Request for City Manager Signature

Project Name/Contract Number:	IH35 at SH123 Bridge Aux Lanes	#0016-03114
Department Contact / Department Name:	Rohit Vij	CIP/Engineering
Date of City Council Approval: (Past or Recent)	2021-31R; March 24, 2021 (Past Approval Date – Contract 0016-03114) August 12, 2021 (AFA Amendment #1) February 17, 2026 (Anticipated Approval Date – SUPP & AFA Amendment #2)	
Return Signed Document to:	Rohit Vij	Ext: 8133

Standard Utility Agreement Supplemental Agreement No. 1 to U Number 15694 Utility ID 00000284

District: Austin
ROW Project ID: R00002549
ROW CSJ: 0016-03-115
Construction CSJ: 0016-03-114
Proposed Highway Project Letting Date: 04/01/2021

**IH 35 AT SH 123
 WASTEWATER
 PLAN AND PROFILE**

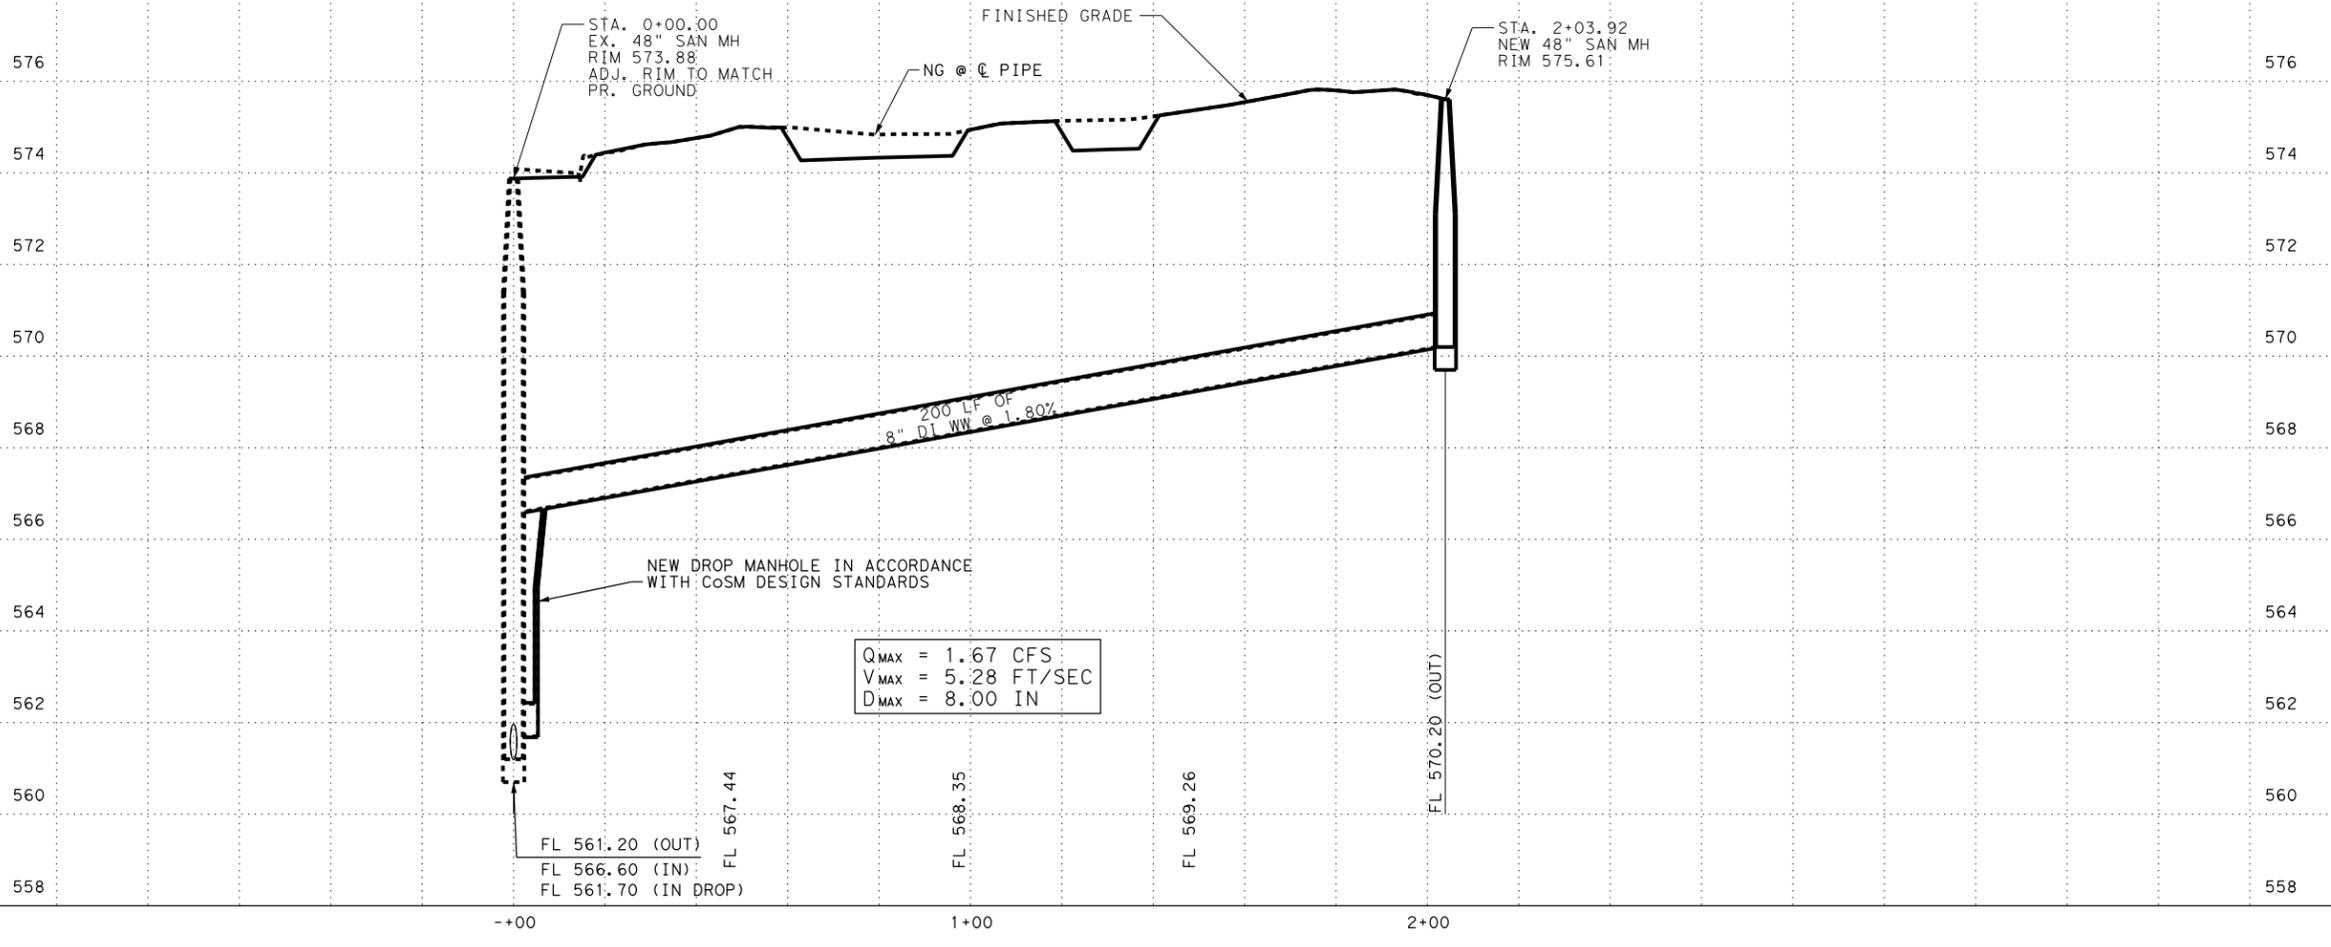
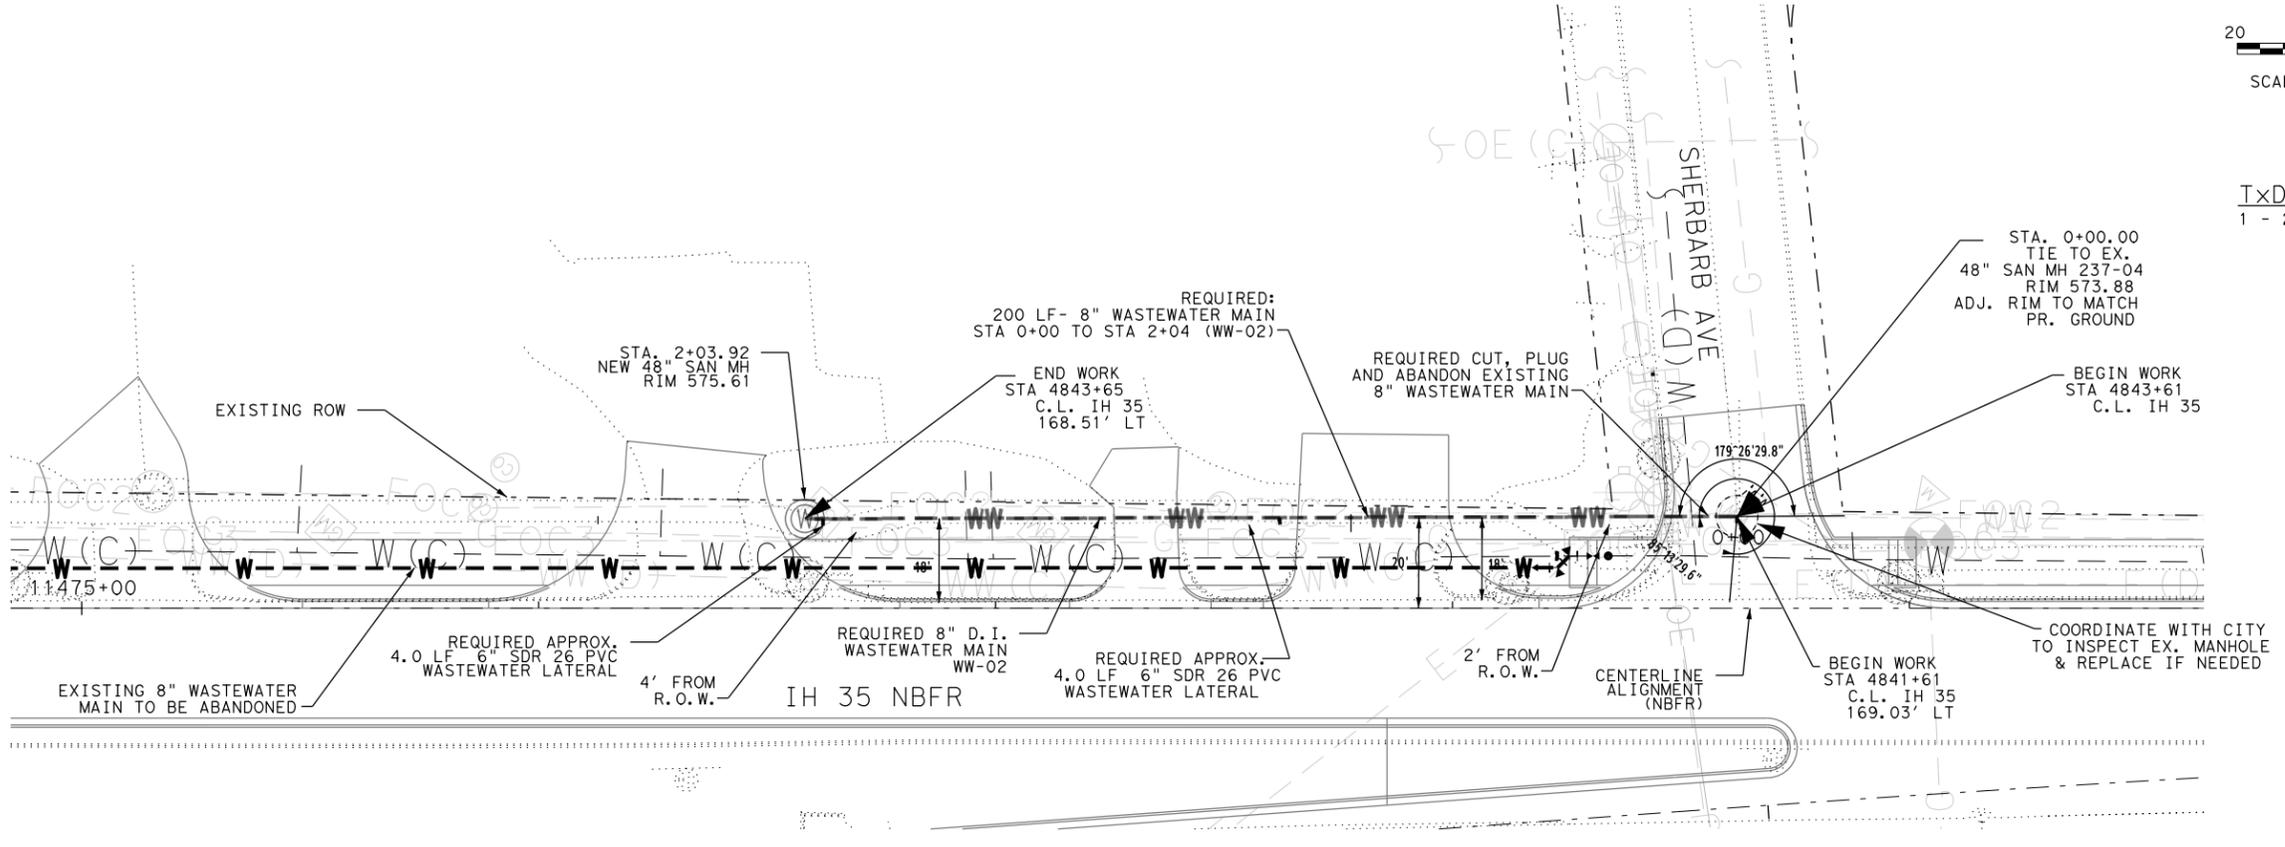
TxDOT CONFLICT REPLACEMENT
 1 - 240 LF 8" WASTEWATER CONFLICT
